SITE PLAN
FOR
JOE KOZLOWSKI
BEING S/L 7, WELLINGTON RIDGE ESTATES SUB'D,
PERRY TOWNSHIP, LAKE COUNTY, OHIO.
Reviewed and Accepted
LAKE COUNTY GENERAL HEALTH DISTRICT
Date 8-7-92
Swale must be deepened before permit will be issued
JOEL LUCIA, R. S., M. P. H.
Health Commissioner
BY Laura Kramikuns
LOW YIELD WATER FIXTURES REQUIRED ON ALL:
Shower Head
Toilet
SEWAGE DISPOSAL PERMIT MUST BE OBTAINED BY A LAKE COUNTY LICENSED INSTALLER BEFORE INSTALLATION IS STARTED.

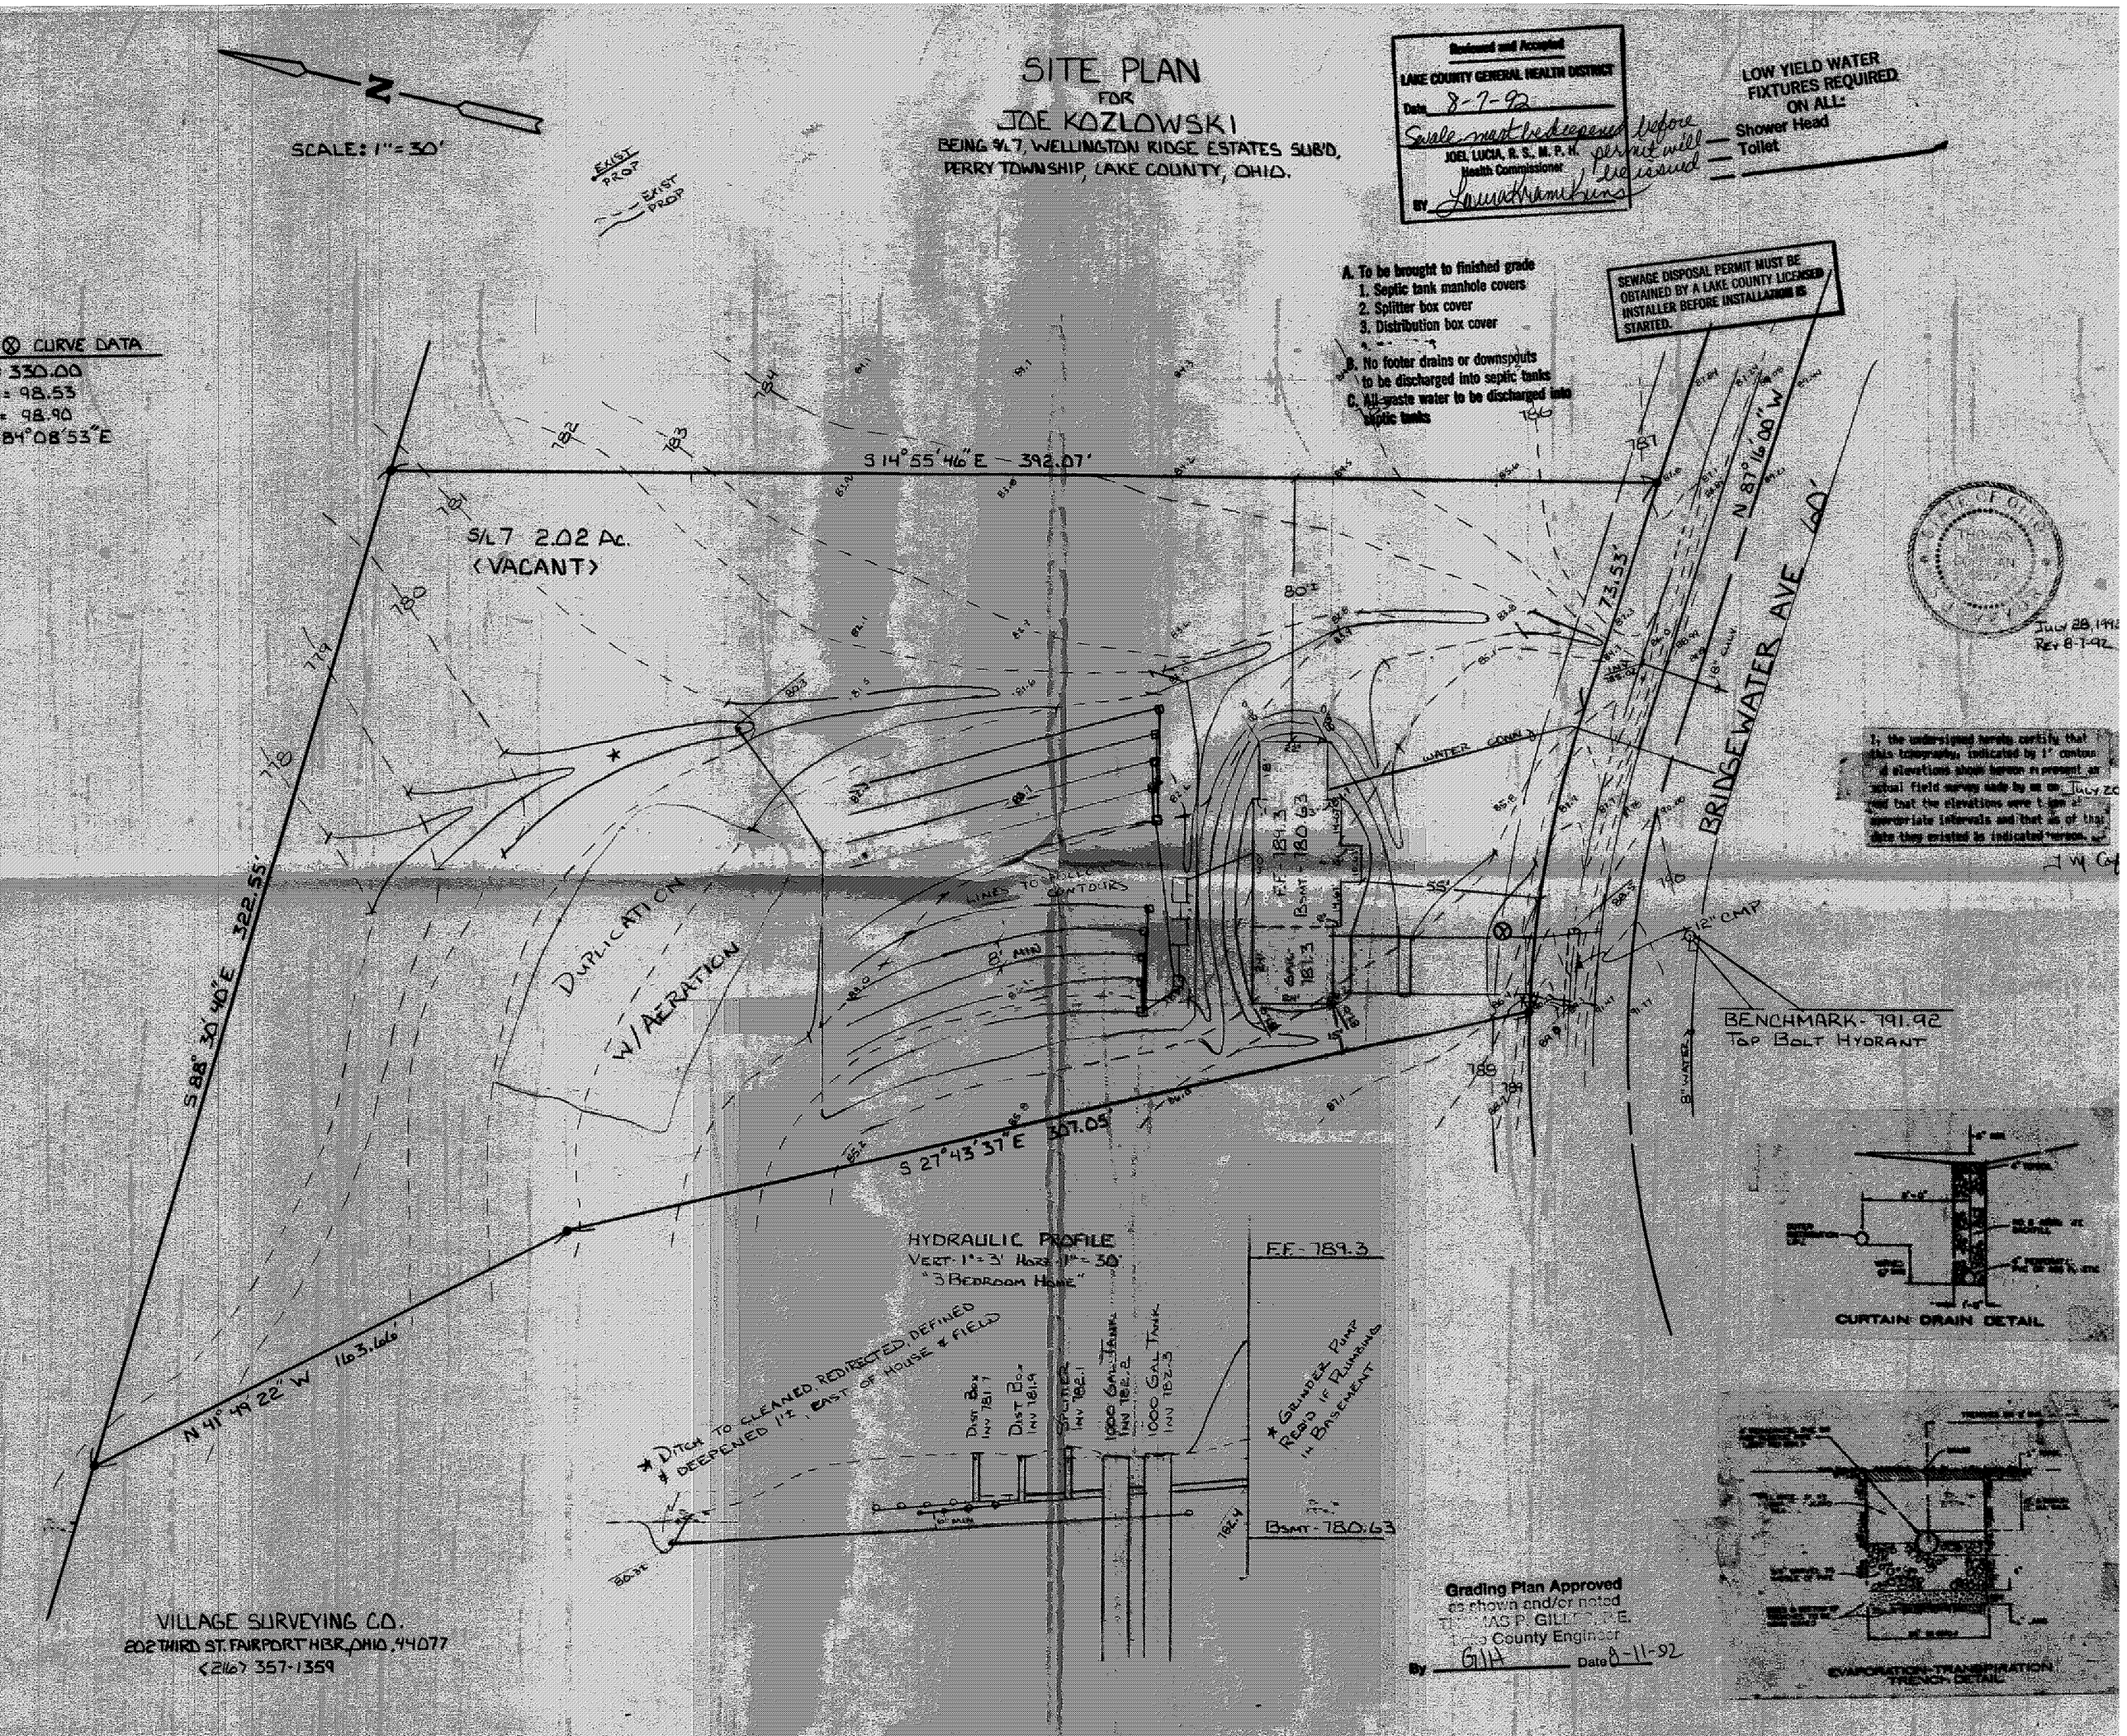
* DITCH TO CLEANED, REDIRECTED, DEFINED & DEEPENED 1'± EAST OF HOUSE & FIELD
DIST BOX INV 781.7
DIST BOX INV 781.9
SPLITTER INV 782.1
1000 GAL TANK INV 782.2
1000 GAL TANK INV 782.3
